# ZAYO'S PRINEVILLE TO RENO PROJECT

## CPUC MINOR PROJECT REFINEMENT FORM

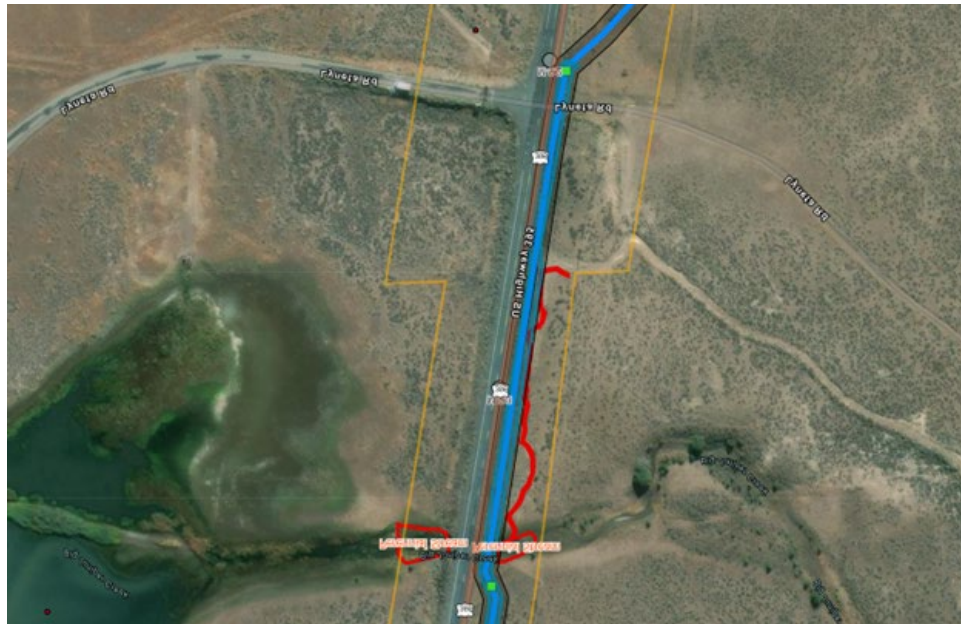
**RFI NO. 0513**  
**MOVE R/L TO 25 FEET FROM**  
**EOP ON THE WEST SIDE. CROSS**  
**ROAD AT STA. 639+77 & BACK**  
**TO EAST SIDE AT 629+46. BORE**  
**UNDER DRIVEWAY FROM STA.**  
**639+00 TO 637+40 AND UNDER**  
**CUVERT AT MP 9.35.**

**Original Alignment East Side of US 395**

**Proposed Realignment West Side of US 395**
